Project number: TOO4

RE: GROUND MOUNTING SYSTEM GT IV

GROUND MOUNTING SYSTEM GT IV

Table 1.0 Maximum Spacing between frame supports (mm)					
Wind Zone	А	В	С	D	
Wind Speed Vs (m/s)	43	52	64	80	
Spacing (mm)	3700	2210	1530	970

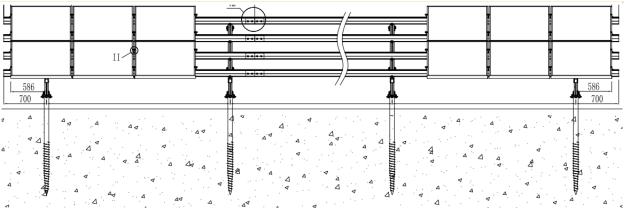
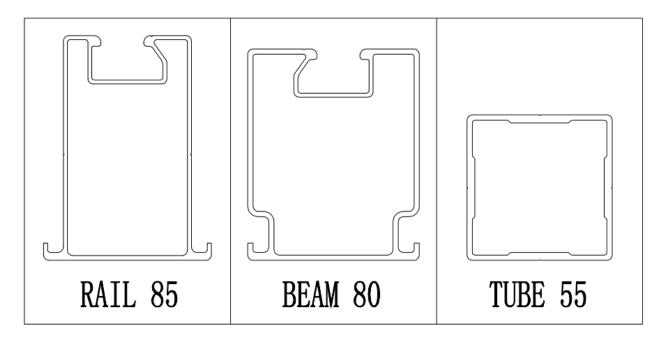
As requested, we have reviewed the structural adequacy of the Aluminium support framing and the fixings specified in 'Ground Mounting System Installation Drawings prepared by SunRack Solar Co. Ltd. The system consists of post mounted frames as shown in the diagrams below. The frames are supported by twin piles at a regular spacing.

We certify that the framing is satisfactory for wind zones A, B, C & D as defined in AS1170.2 for the spacing of the frames as given in Table 1.0.

- Cantilever span L1 shall not exceed 30% of the internal spans. Minimum number of frames: 3 (i.e. two spans)
- The table is based on 72 cells PV panels (1950 long). The spacing would increase when used with 60 cell PV panels (1650 long).
- The given spacing is for an inclination of 30 degrees. The spacing can be increased further by reducing the tilt angle in steps of 5 degrees.
- Any amendment of spacing shall be designed and certified by a practising structural engineer.

Table 2.0 Ultimate Forces at Post Base						
Wind Zone	А	В	С	D		
Moment M (kNm)	1.9	1.9	1.9	1.9		
Shear V (kN)	9.8	9.8	9.7	9.7		
Compression Nc (kN)	9.2	8.7	8.5	8.3		
Tension Nt (kN)	19.1	19.1	19.1	19.0

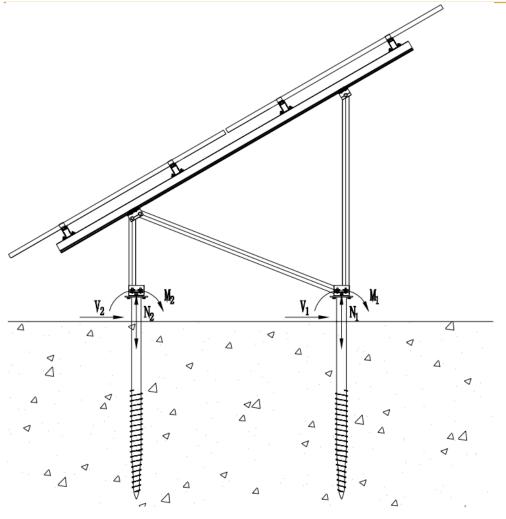
- The installation of the framing shall conform to relevant Australian Standards, Manufacturer's specifications and good building practice.
- The piled embedment shall be designed to resist the ultimate loads given in Table 2.0 above.
